PLANNING REPORT

**1. Oak Park Residential Mitchell-Dewitt and Hyland Croy Roads
07-001FDP/FP Final Development Plan/Final Plat**

Proposal: An amendment to a previously approved final development plan and final plat to correct the lot depths and the size of a reserve area within the Oak Park Planned Unit Development located at the southwest corner of Mitchell-Dewitt and Hyland Croy Roads.

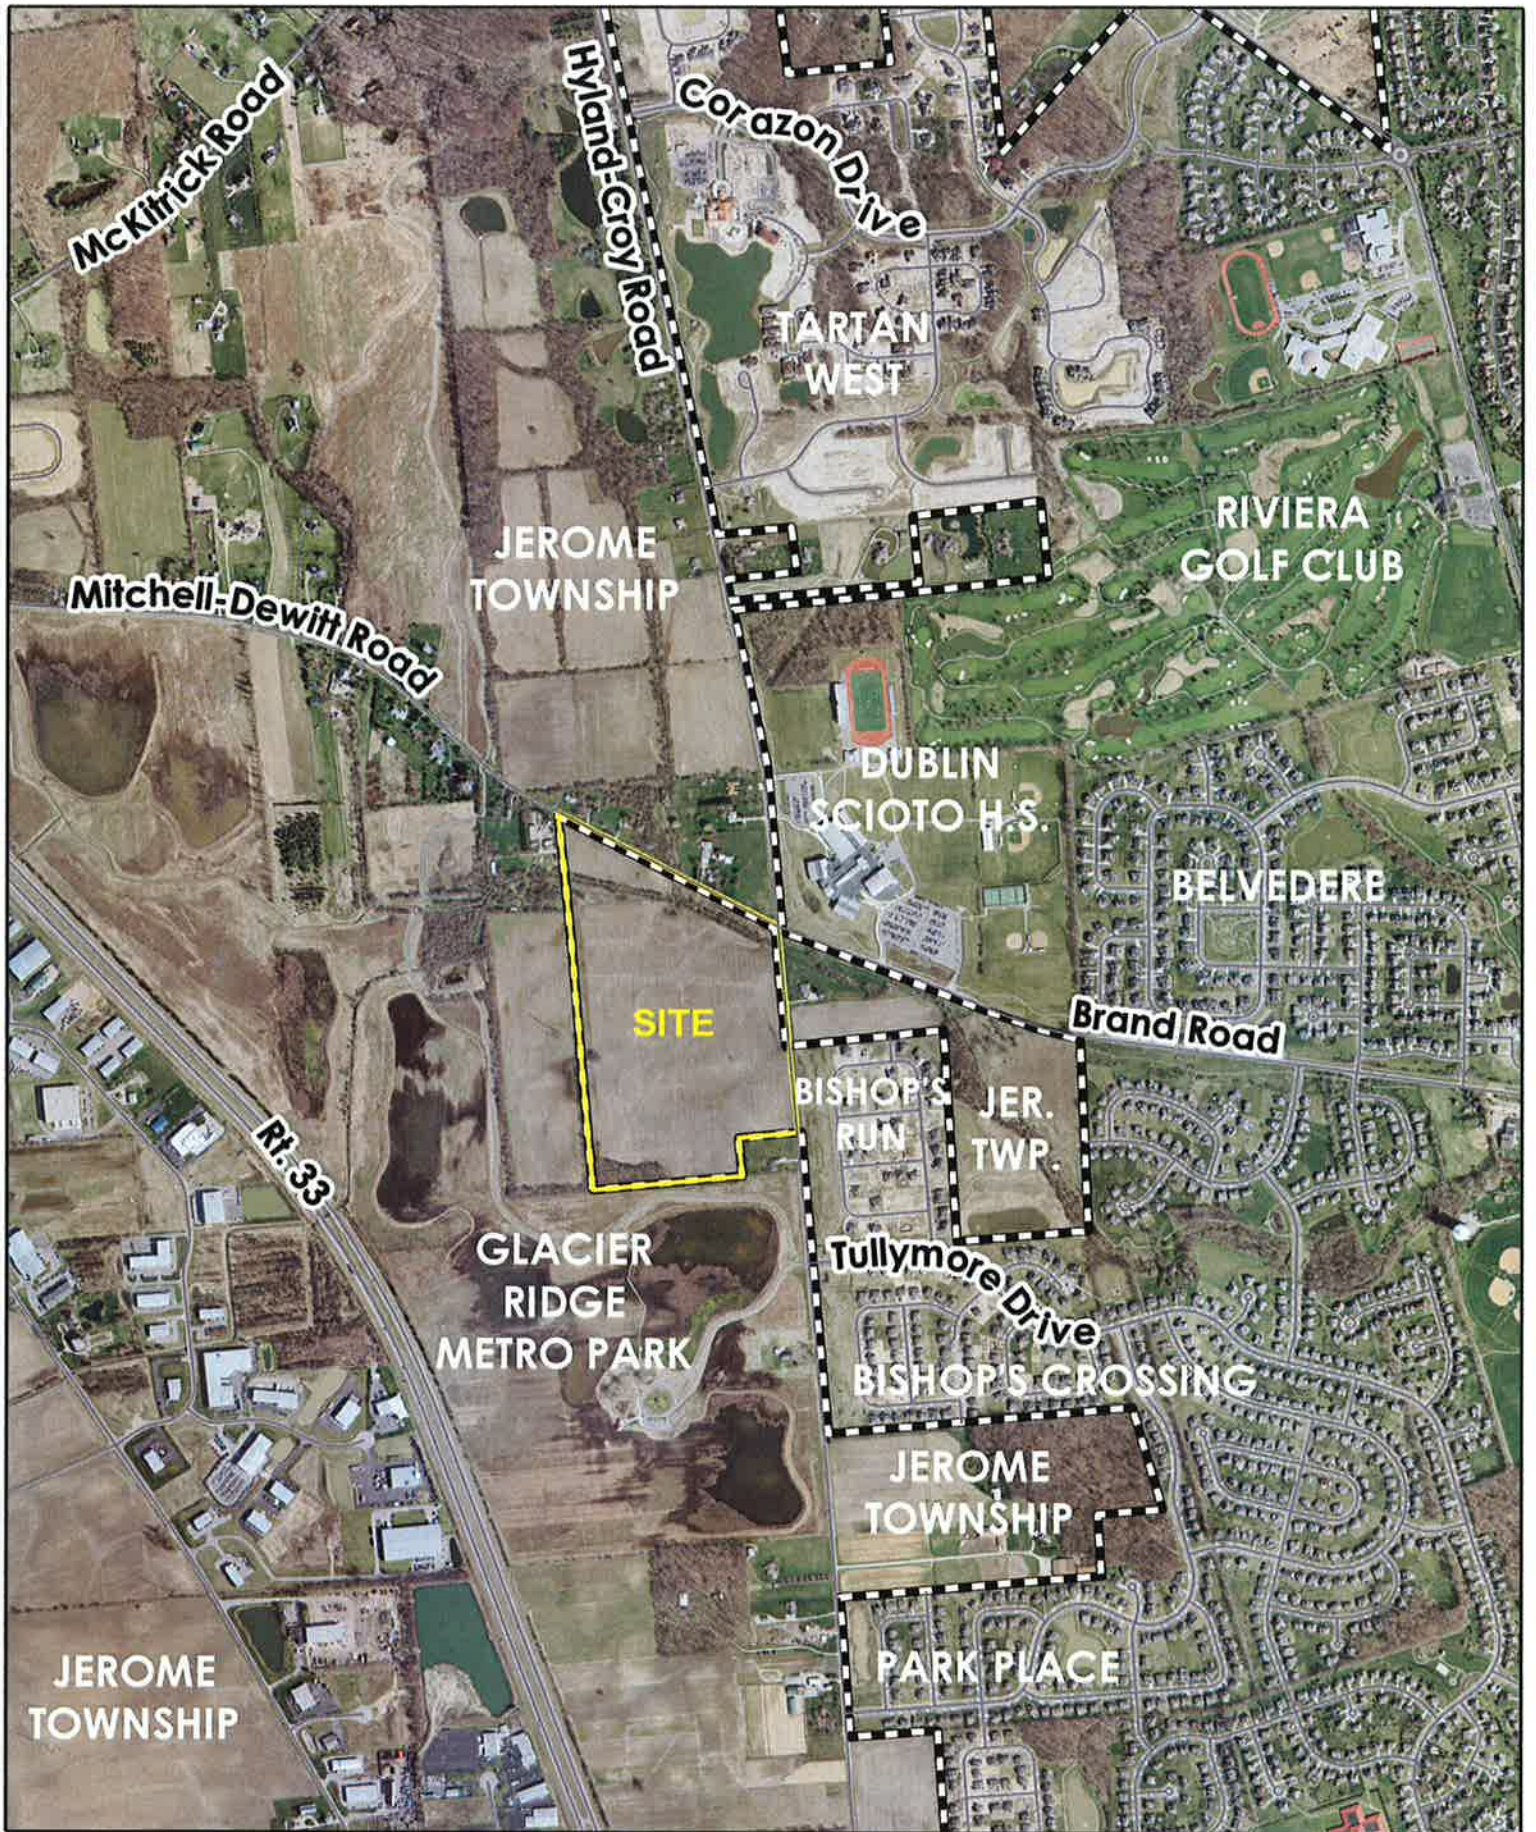
The proposed amendment to the final plat will extend the depth of Lots 9 and 10, two of 33 Park Homes within Subarea A of the development. The lots front on Greenland Place at the terminus of Oak Meadow Drive in the southeast portion of Oak Park. The approved development text of the Oak Park development requires a minimum lot depth of 125 feet for Park Homes and the approved final plat incorrectly shows lot depths of 115 feet for both lots. This application will correct the lot depth error depicted on the approved plat.

This proposed amendment will also modify the area of Reserve F, located in the southeastern portion of the site, adjacent to the Glacier Ridge Metro Park. As Lots 9 and 10 must be extended in order to comply with the approved development standards, Reserve F will be reduced from 6.291 acres to 6.256 acres, a reduction of 0.035 acre. The approved development text requires a minimum of 30.6 acres of open space within the development. With the reduction of 0.035 acre proposed with the amended plat, the total amount of open space will be 31.3 acres, which will continue to meet the open space requirement for this development.

Reserve F is owned and maintained by the City of Dublin as passive open space and the plat amendment will not modify ownership or maintenance responsibilities. There is a significant mature tree stand in the southwest corner of this reserve and with this modification, some trees will be located on Lot 10, which should be incorporated within a No-Disturb Zone.

Criteria may be met with condition: The plan incorporates many existing trees within the reserve areas. In order to ensure the preservation of these natural features, a 20-foot No-Build Zone should be provided along the rear of Lot 10 (Condition #2).

- 1) That a 20-foot No-Build Zone be provided along the rear of Lot 10.
